ADDENDUM

Project Name: New Annex Building
 Loving County
 100 Bell St.
 Mentone, Texas 79754

Addendum No.: **Two (2)**
 Date: February 19, 2010
 Project No.: 09080

SUPPLEMENTAL DRAWING NO. SD-1

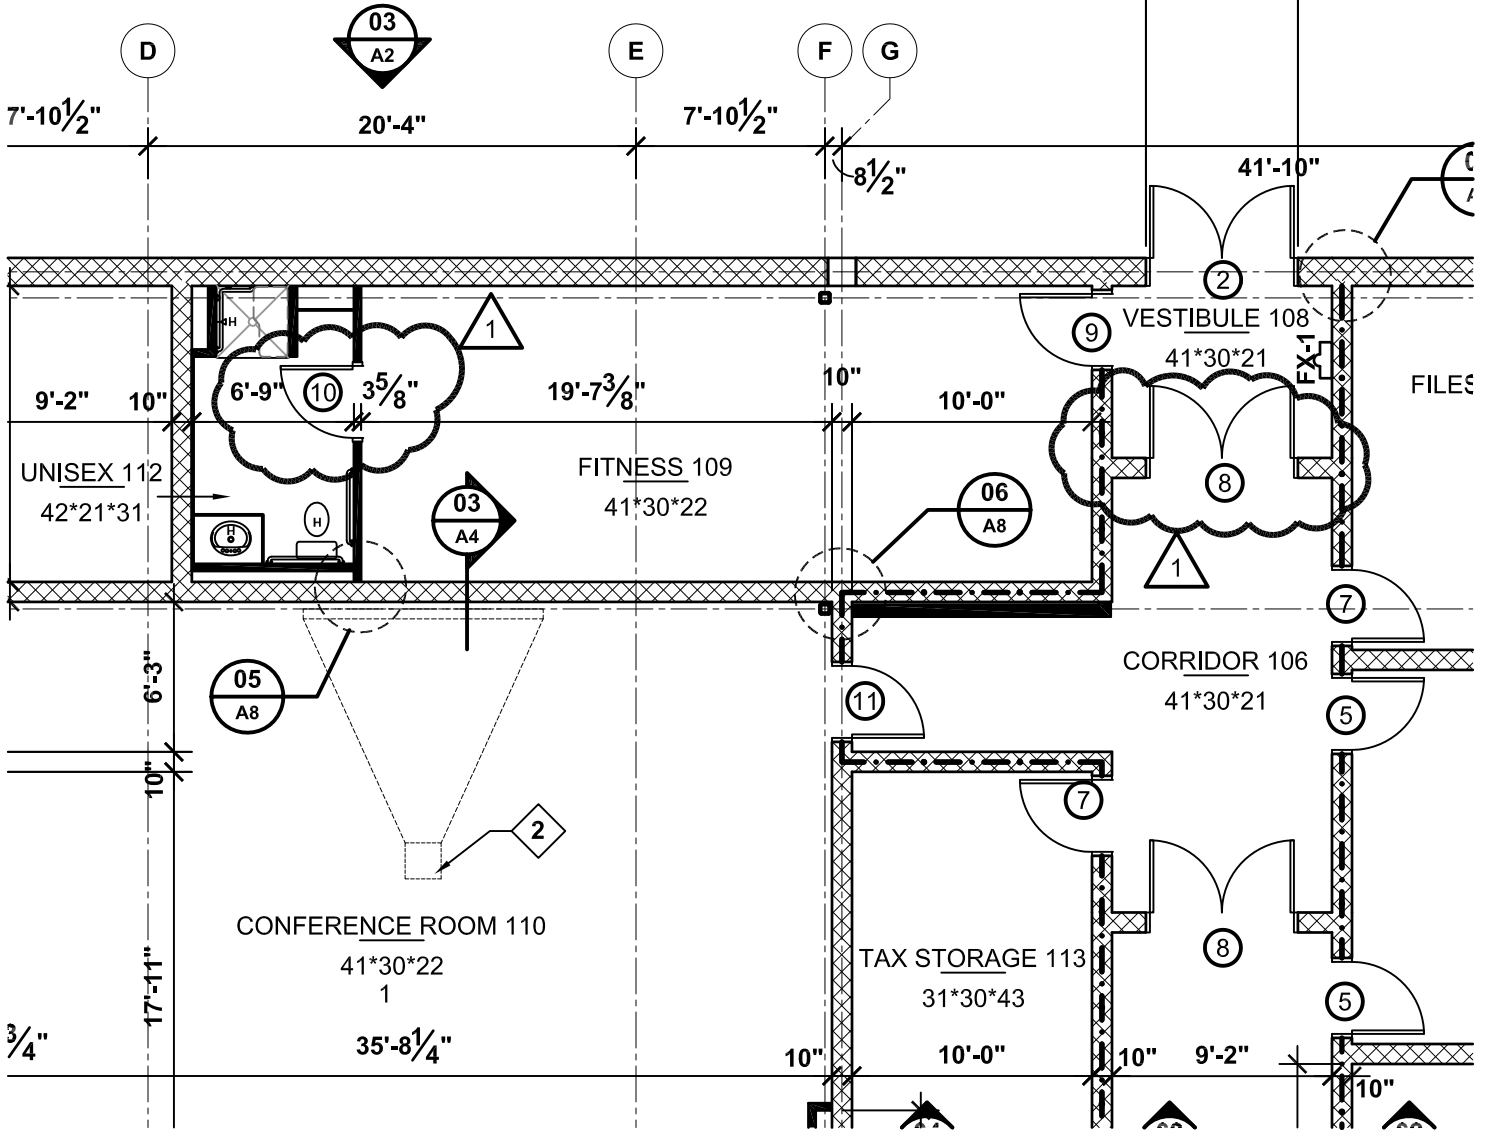
- Item No. Eight:** In the Drawings, Sheet A1 – Floor Plan; for clarification purposes make the following changes included but not limited to.
- A. For clarification purposes add vestibule door and wall as shown on attached supplemental drawing SD-1 attached herewith.

- B. For clarification purposes add door tag ten (10) to Unisex 112 private bathroom door as shown on attached supplemental drawing SD-1 attached herewith.
- C. For clarification purposes doors no. 5, 7, 9, 12, 14, and 17 are all required to be 20 minute doors
- D. For clarification purposes window W4 is required to be 45 minute rated.
